## Engineers Comments Regarding Surface Water Drainage

| <b>Application Reference:</b>   | AL/27/26/RES                                                                                                                                                                                                                                                                                                                                                                     | <b>Reviewer Reference:</b> | ADC/EXT4b  |
| <b>Site Name:</b>               | Land West of Lidsey Road (A29) Lidsey PO22 9RG                                                                                                                                                                                                                                                                                                                                   |                            |            |
| <b>Assessment Number:</b>       | 1 of 2

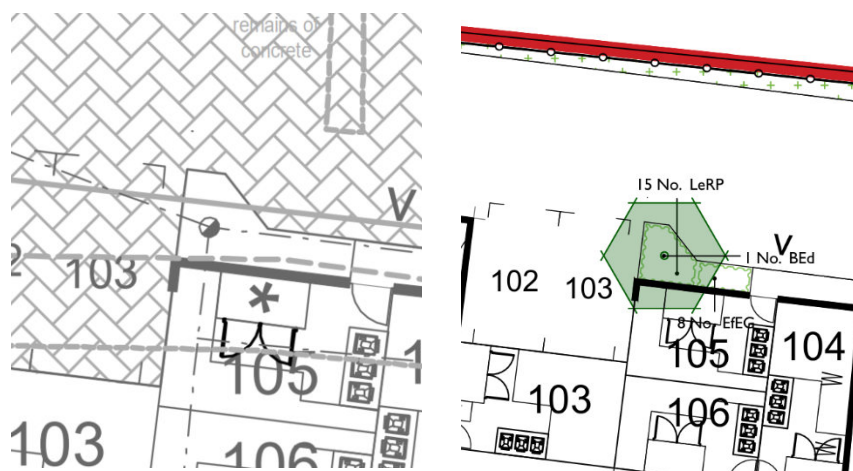
5.2. The side slopes of 2 of the basins are 1:2. This contradicts design guidance and present maintenance challenges. Side slopes are expected to be a maximum of 1:3 gradient. This will affect the scale and layout of the development and would warrant objection.
